City of Toronto – Parks, Forestry & Recreation

# New Park at 44 Jackes Avenue

## What We Heard: Phase 1 Engagement Summary

December 2021

### New Park on Jackes Concept Design

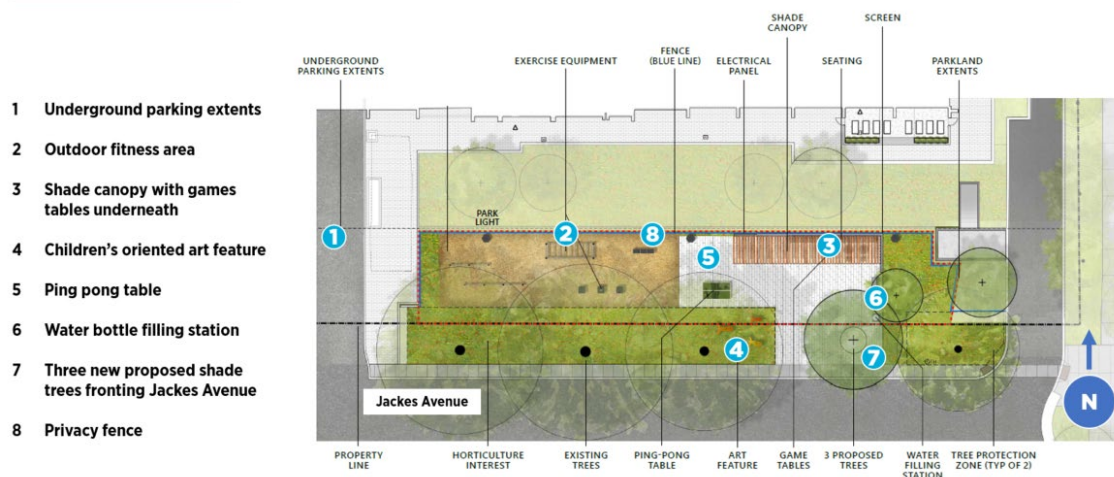
- Generally, the park design was not well-received by community members attending the meeting
- Noise, privacy and security were critical issues brought forward by attendees (some of whom live next to the new park) and will be addressed by the project team during the next round of consultation

- Many suggestions from attendees to “keep the space as it is” rather than over programming it
- Suggestions to depart from the park concept's amenities and features and instead create a quiet park space that incorporates sensory planting, quiet seating areas, walking paths, and thematic paving or rock elements

- Redesign the park to create a quieter, reflective, and green “oasis” space to be used by residents living in the building connected to the park (44 Jackes Avenue) and other community members (17)

- Some respondents commented that the concept design was over programmed for the area’s demographic, size of the space, and proximity to David Balfour Park (4)

- Some respondents commented that they disliked the games tables and/or ping pong tables [11]
- Leave the current green space as it is (7)
- Add a children’s play structure to consider the area’s growing demographic of new young families, and to make up for no children’s programming in David Balfour Park (4)

- Please remove the ping pong tables and add more green space with bench seating and a fountain. The large park next door has ample room to put ping pong tables and fitness area. Residents in the area (who live directly above and neighboring towers should be given consideration from noise.
